The Incorporated Owners of Hongkong Garden

**Re: Remedial Proposal by Building Department**

**Blitz Unauthorized Building Works Clearance Operation of Buildings Department  
Hongkong Garden**

Remedial Proposals

**Proposal 1:**

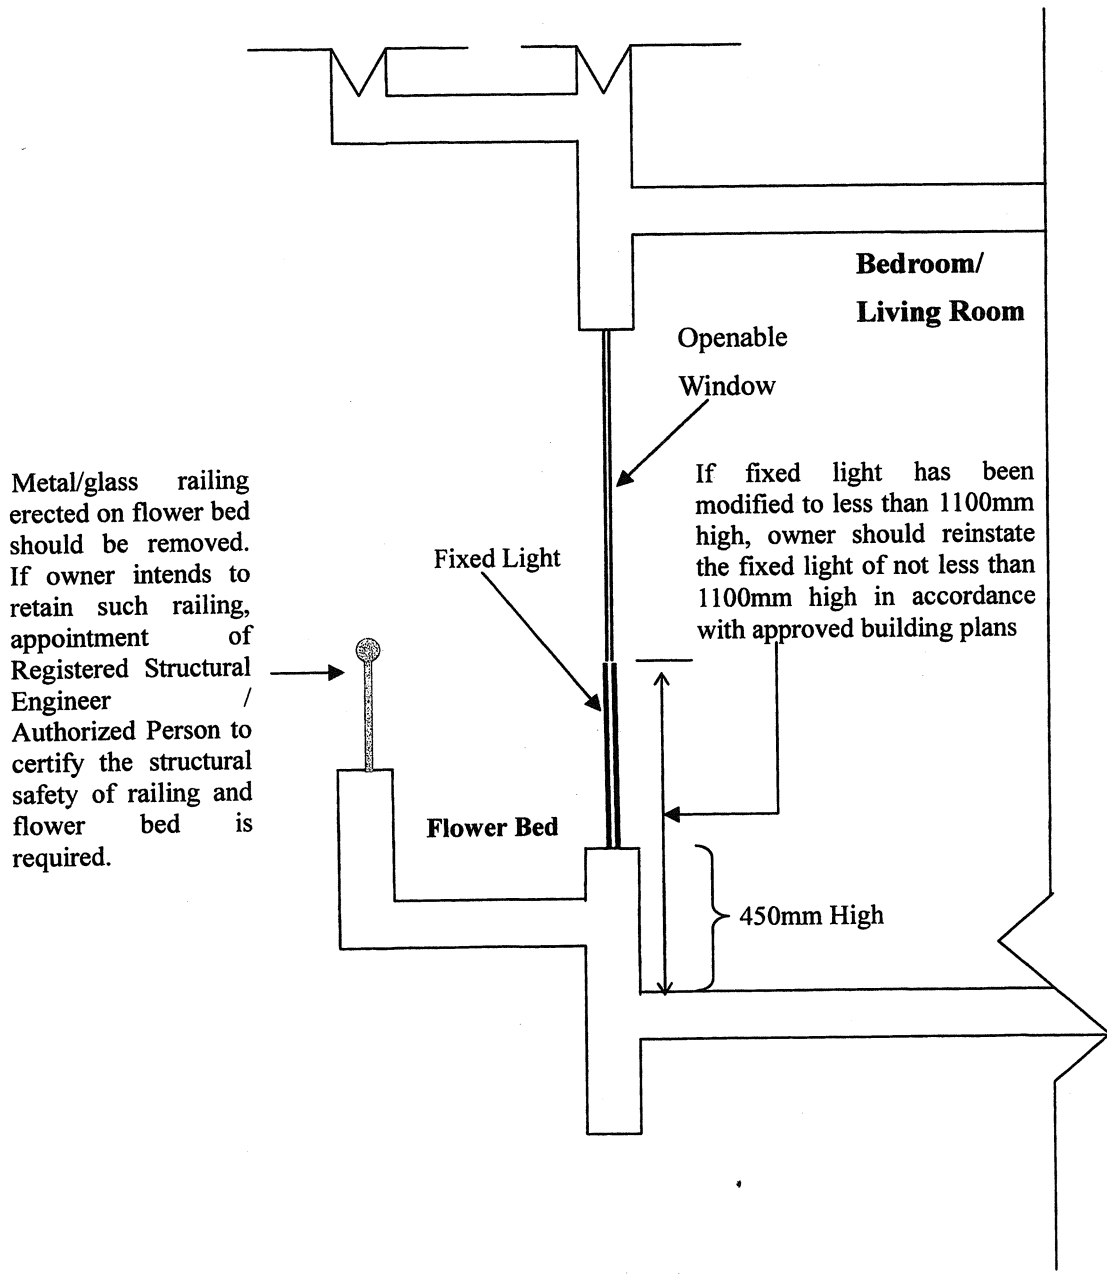
1. If the owner intends to retain metal/glass railing erected on flower bed, appointment of an Authorized Person / Registered Structural Engineer (AP/RSE) to submit structural justifications to BD to certify the structural safety of railing and flower bed is required. If the fixed light between the living room/bedroom and the flower bed has been modified to less than 1100mm high, the owner should reinstate the fixed light to not less than 1100mm high in accordance with approved building plans. **(Proposal 1)**

**Proposal 2:**

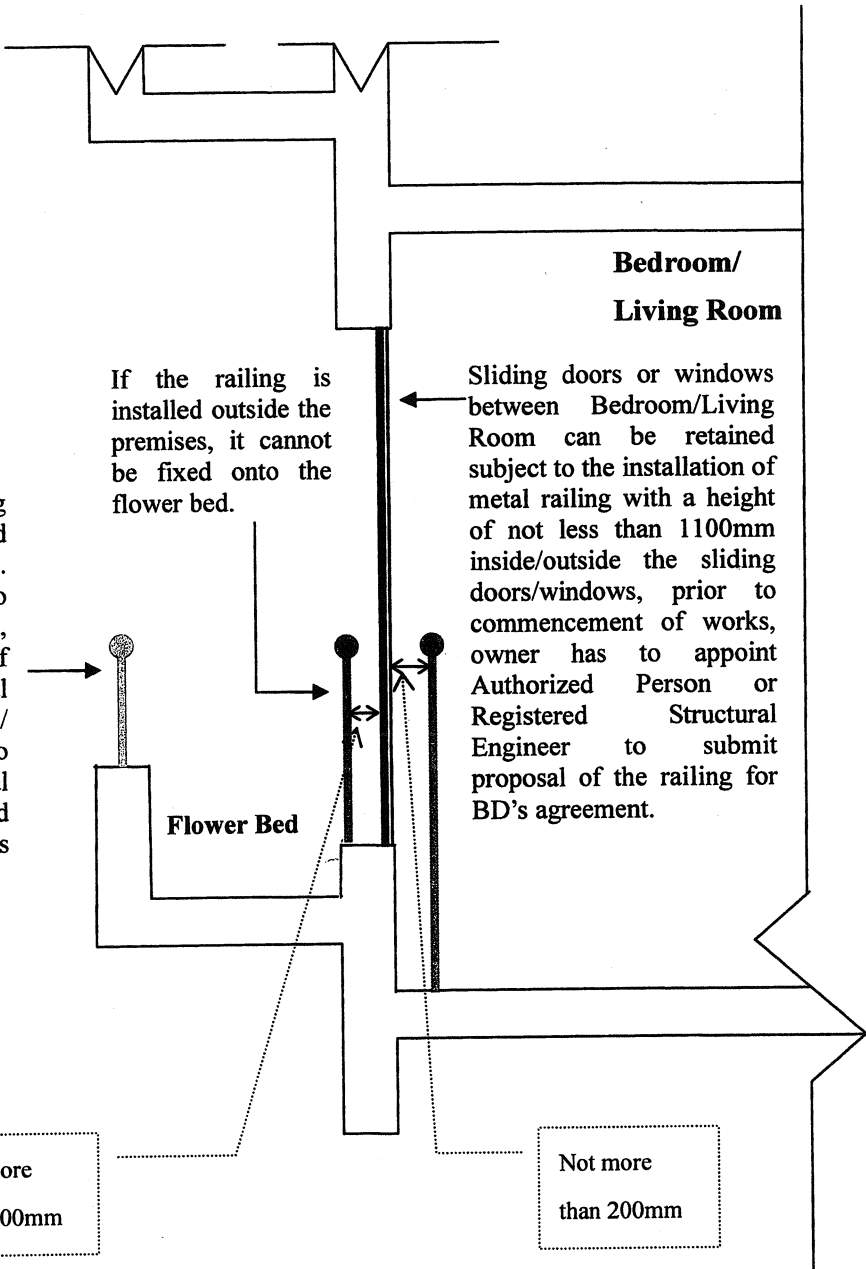
2. Apart from appointment of an AP/RSE to submit structural justifications to BD to certify the structural safety of railing and flower bed, the owner is required to install a metal railing with a height of not less than 1100mm outside (space not more than 100mm) or inside (space not more than 200mm) the sliding doors/windows; prior to the commencement of works, the owner has to appoint an AP/RSE to submit design proposal of the railing to BD for agreement. **(Proposal 2)**

Metal/glass railing erected on flower bed should be removed. If owner intends to retain such railing, appointment of Registered Structural Engineer / Authorized Person to certify the structural safety of railing and flower bed is required.

If the railing is installed outside the premises, it cannot be fixed onto the flower bed.

Sliding doors or windows between Bedroom/Living Room can be retained subject to the installation of metal railing with a height of not less than 1100mm inside/outside the sliding doors/windows, prior to commencement of works, owner has to appoint Authorized Person or Registered Structural Engineer to submit proposal of the railing for BD's agreement.

Not more than 100mm

Not more than 200mm

Proposal 3:

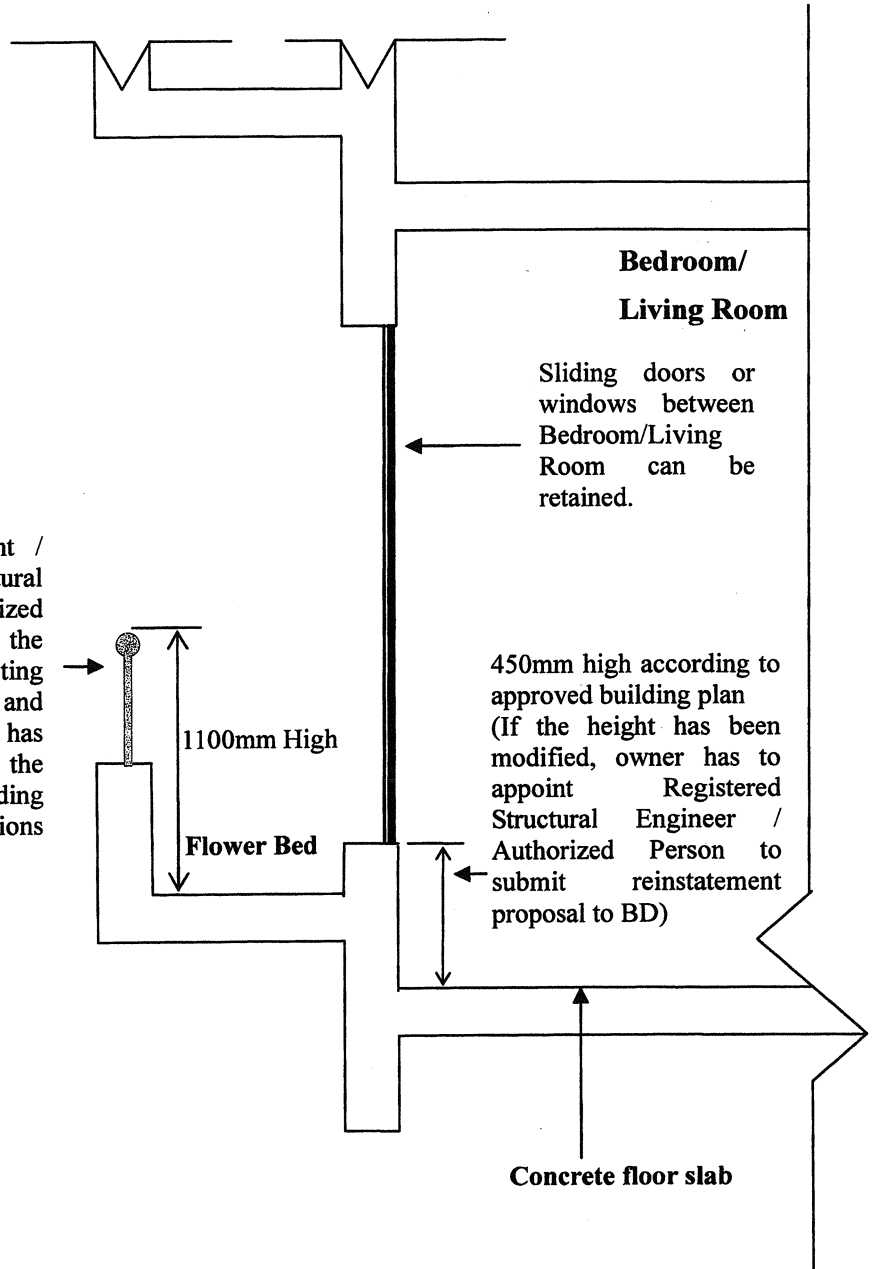
3. If the owner does not intend to install a metal railing with a height of not less than 1100mm outside or inside the sliding door/window, the owner has to appoint an AP/RSE to submit structural justifications to BD to certify the structural safety of existing metal/glass railing and flower bed, the railing has also to comply with the requirements of Building (Construction) Regulations 8 & 17(3), in order to minimize the risk of persons or objects falling through gaps in the railing, or persons climbing over the railing. If the existing low parapet wall between the living room/bedroom and the flower bed has not been modified, the corresponding height should be 450mm according to approved building plans, the owner can retain the unauthorized sliding door/window between the living room/bedroom and the flower bed, otherwise the owner has to appoint an AP/RSE to submit reinstatement proposal of the parapet wall to not less than 450mm high to BD. **(Proposal 3)**

Owner has to appoint / Registered Structural Engineer / Authorized Person to certify the structural safety of existing metal/glass railing and flower bed, the railing has also to comply with the requirements of Building (Construction) Regulations 8 & 17(3).
